**LEGAL ADVERTISEMENT
HISTORIC PRESERVATION BOARD
CITY OF PORTLAND
Public comments will be taken at all meetings**

On Wednesday, June 4, 2014 at 5:00 p.m., the Portland Historic Preservation Board will meet in Room 209 of City Hall to review the following items:

**HISTORIC PRESERVATION BOARD
CITY OF PORTLAND, MAINE**

**PUBLIC HEARING
1 CARROLL STREET**

1 EAST ELEVATION
2 SCALE: 1/4" = 1'-0"

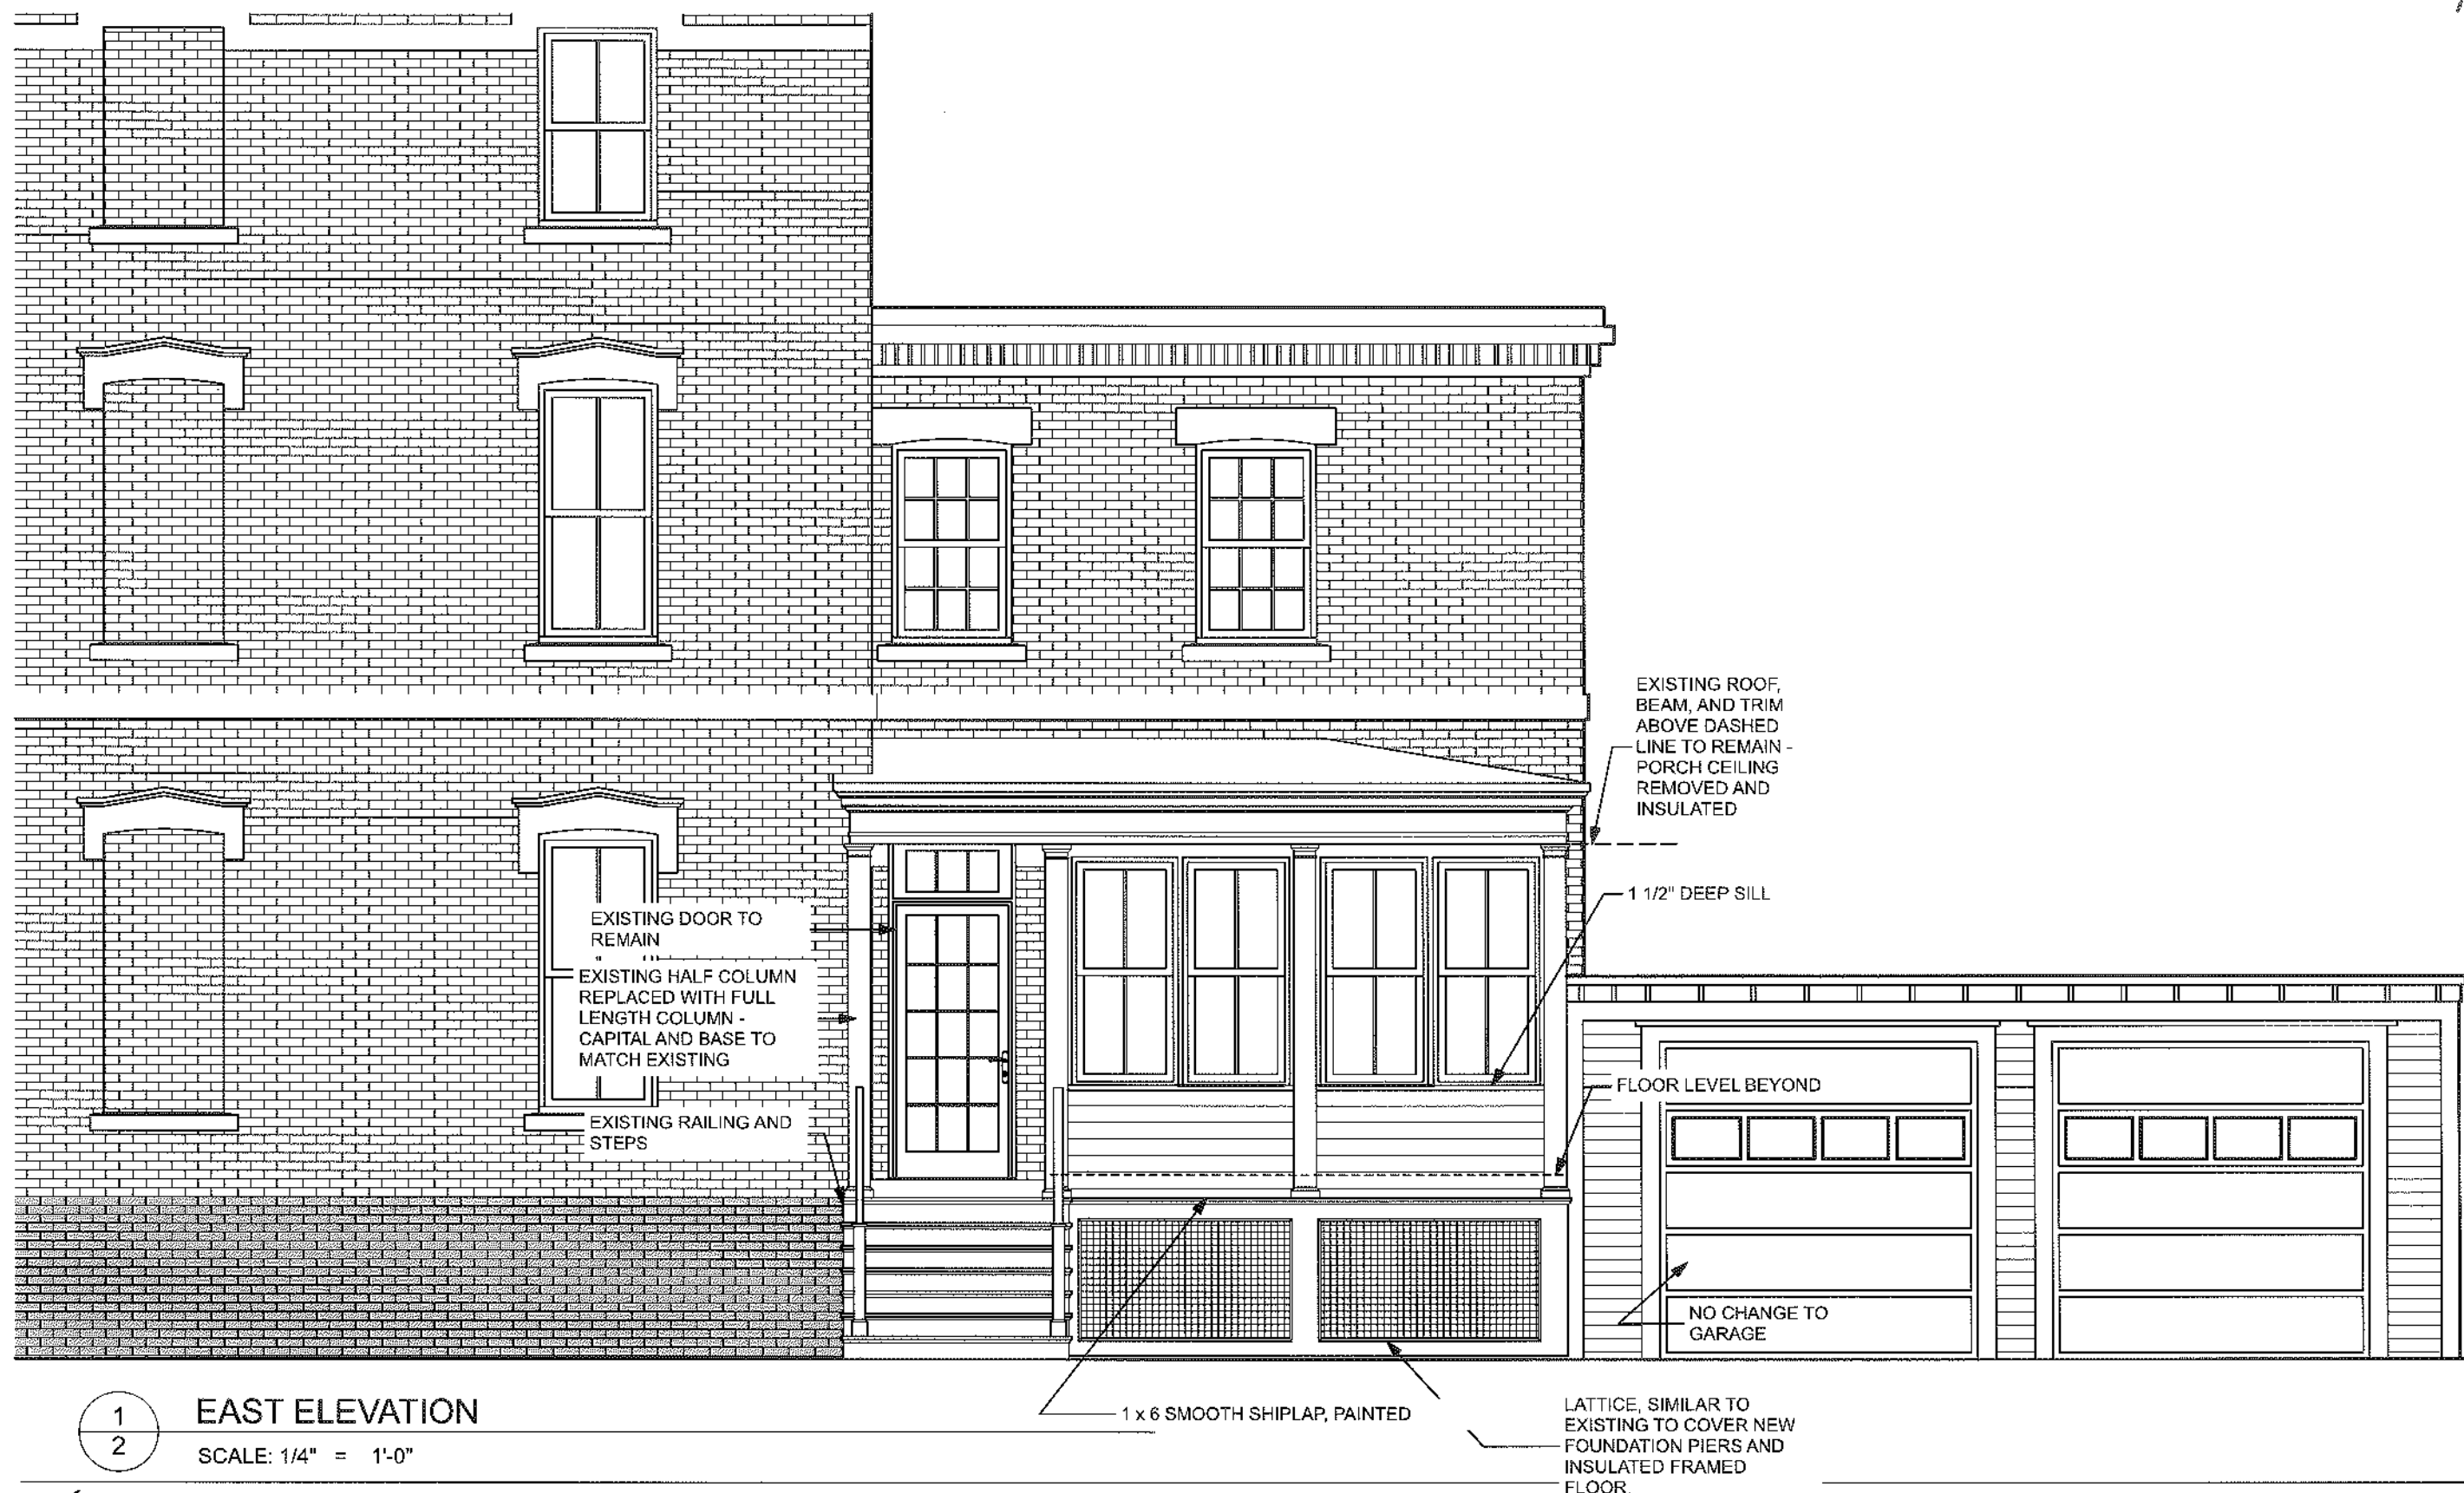
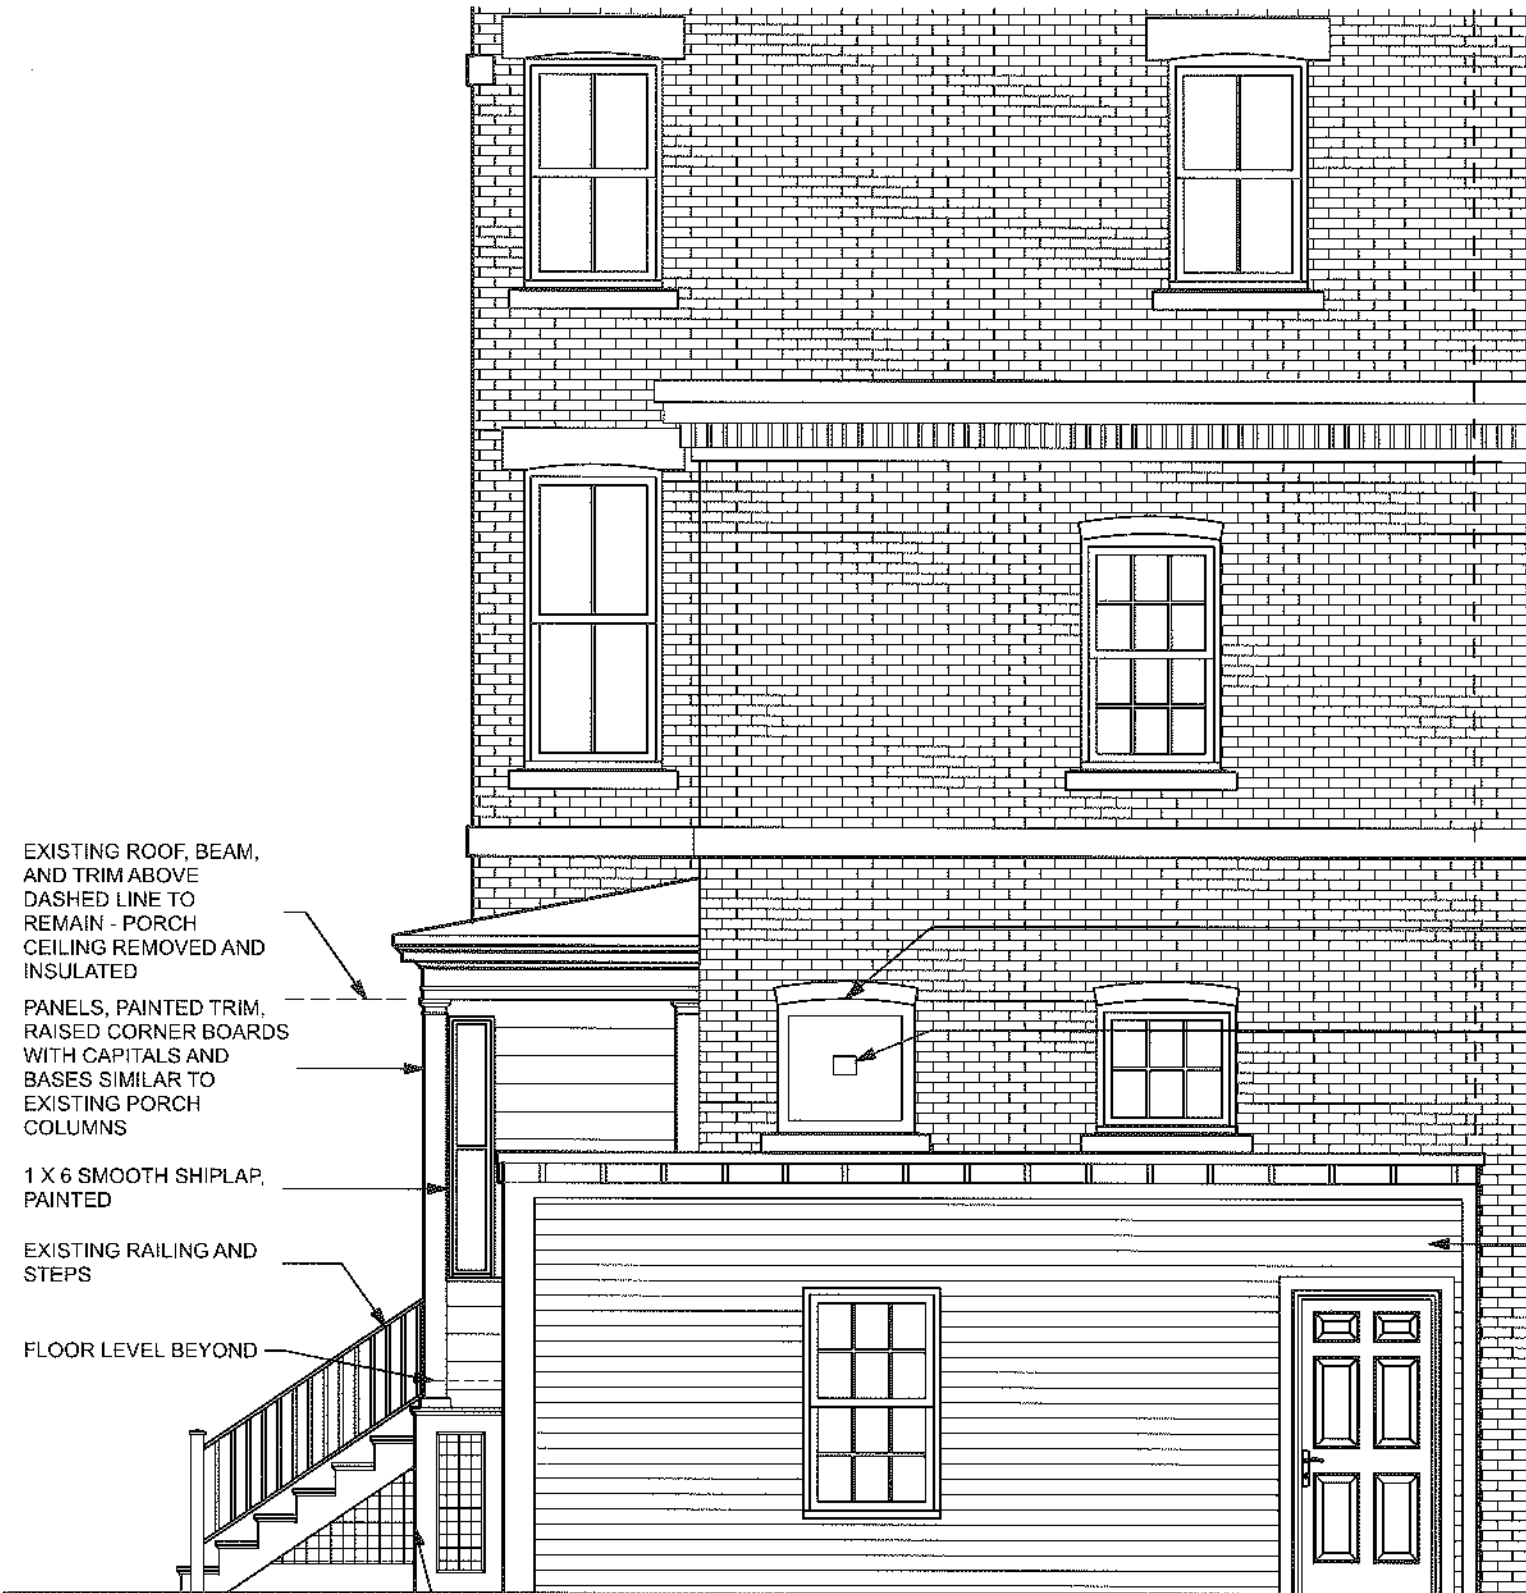
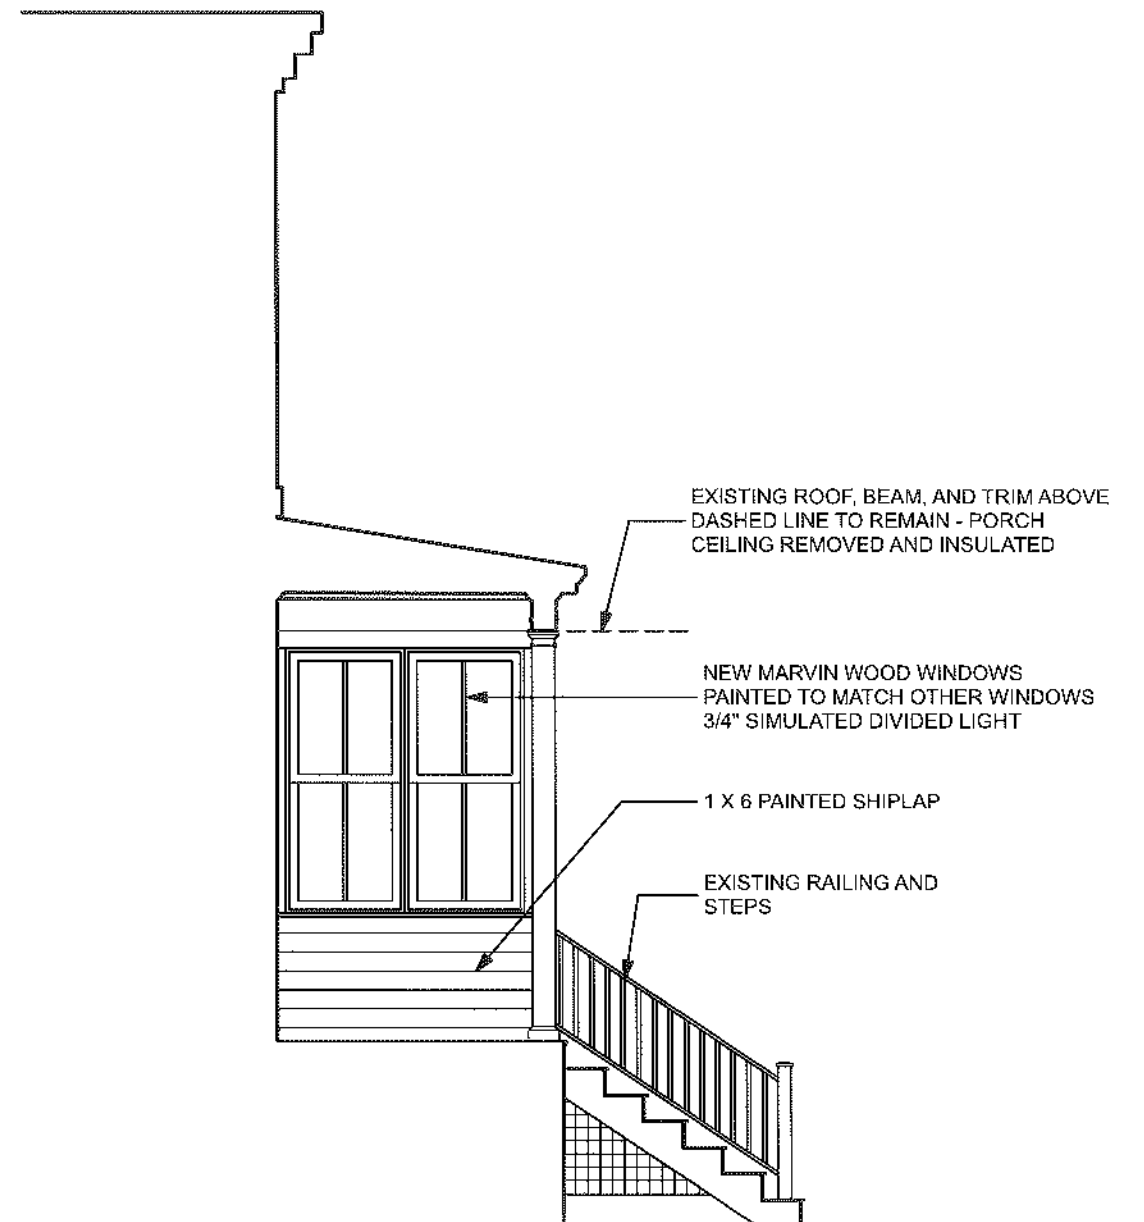
The new elevations, wall section, and narrative present more changes in response to the concerns where the Board came closest to consensus. Inside, the half columns at the north and south ends of the removed wall, along with the supporting beam, are all proposed to be wrapped with painted wood; in the last proposal the tile backsplash surrounded the north post as well; now the tile wrapping the painted north post has been eliminated. On the exterior columns, bases, and capitals on the prominent Thomas Street face appear to match the existing except that the columns and window sills are proposed to have greater depth than in the last iteration of the plans. In conjunction with proposing flush painted board siding on the north wall, the east wall is shown with the same treatment in the latest elevation.

On the exterior of the Thomas Street (east) wall, Board members are presented with somewhat more robust columns and window sills, and must decide whether the current proposal is strong enough to relate to the house appropriately. It is perhaps worth noting that the width of the columns, their capitals, and the bases all match the existing columns of the porch, but the columns have been deepened to stand out more, and they are more pronounced in that façade with the addition of the middle column added for the version of the plans reviewed on March 19. The Board may want to discuss whether they seek details that are bolder than those on the existing porch, or should the existing models be emulated as past changes that have acquired significance in their own right. Staff also wonders whether the thickness of the window sill should be increased to have a stronger presence.

On the north wall, the combination of a narrow window akin the main face of the porch enclosure and simple, smooth siding may come closer than any of the previous plans to a compatible solution for this face. Staff believes the Board will be comfortable with the proposal of Marvin wood windows, rather than a clad version.
